## *Jerrabomberra Residents Association Inc.*

The Canberra International Airport (CIA) has released their draft Practical Ultimate Capacity ANEF (Australian Noise Exposure Forecast) for Canberra airport for 2050.

New draft Practical Ultimate Capacity ANEF  
over Proposed 2031 Strategy

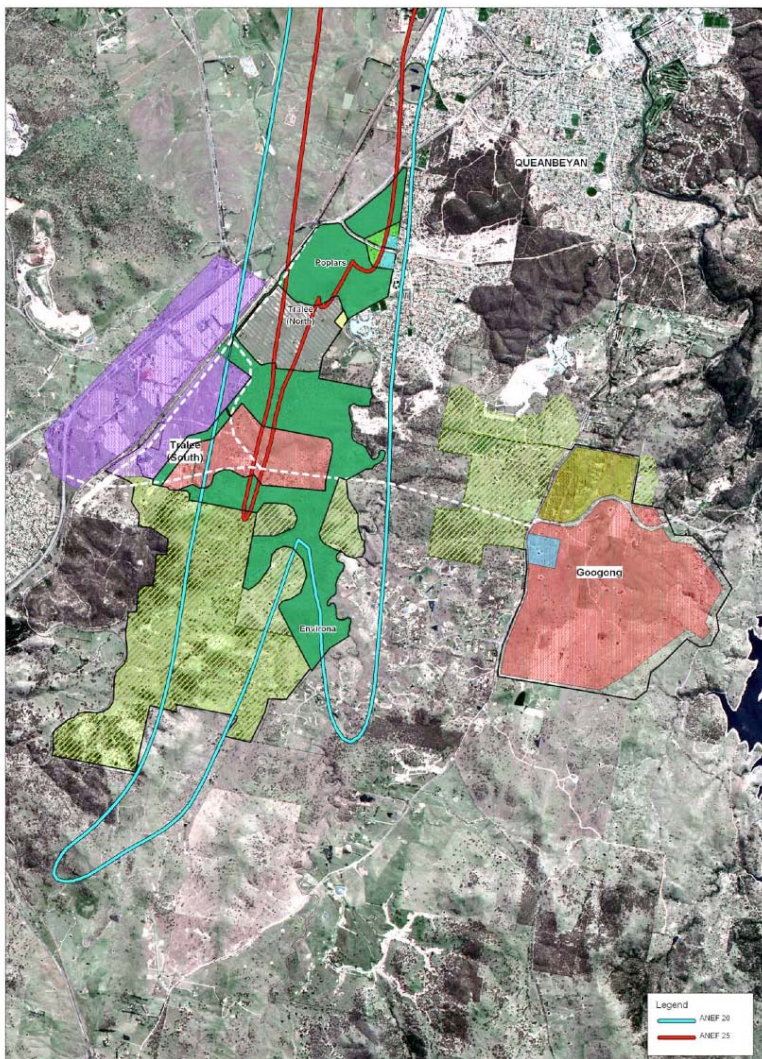
**It means that if this is approved by Air Services, that the high school cannot be built inside the blue line (ANEF20) and this has once again stalled the development in the Jerrabomberra Valley that will help deliver important community infrastructure - like the school and aquatic centre.**

The JRA will be making a submission to the draft ANEF. We have real concerns regarding the assumptions (the proposed number of flights) that underpin the model as we believe they are over inflated. We are also concerned that given 70% of planes that have the RNP technology continue to use the offset approach over Jerra on the runway centre line, this practice will continue in the future.
